## S E R V I C E N O T E

**37711A T1/Datacom Test Set**

**New firmware fixes fatal error 421 when printing Datacom Graph**

A2 Component Location Layout

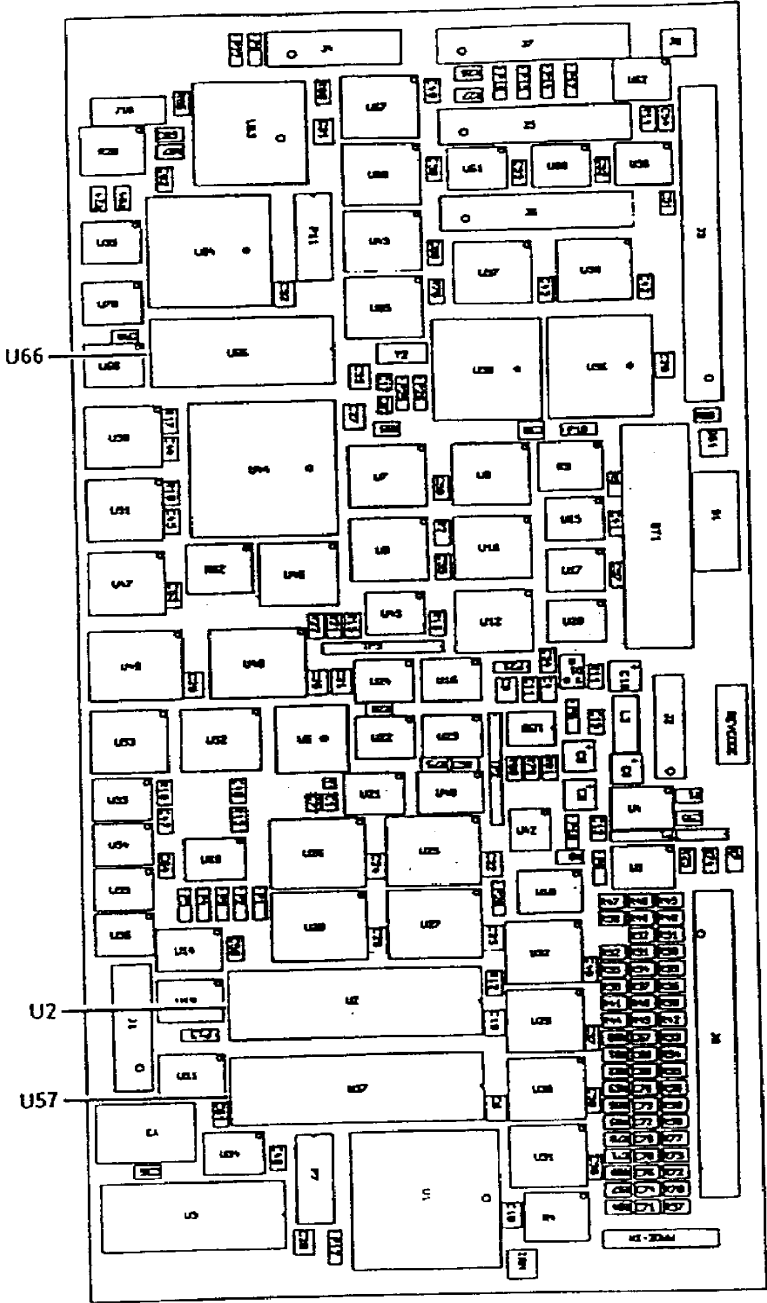
Replace Processor Assembly A2 Prom parts 37701-80025 (A2U2) and 37701-80027 (A2U57) with part number 37701-80035 and 37701-80037 respectively. Use the following procedure from PROM replacement.

1. Use the Component Location layout to identify the parts to be replaced (fitted on sockets) and remove the existing A2U2 and A2U57 parts.
2. Fit the new Proms as follows: A2U2 - 37701-80035, A2U57 - 37701-80037.
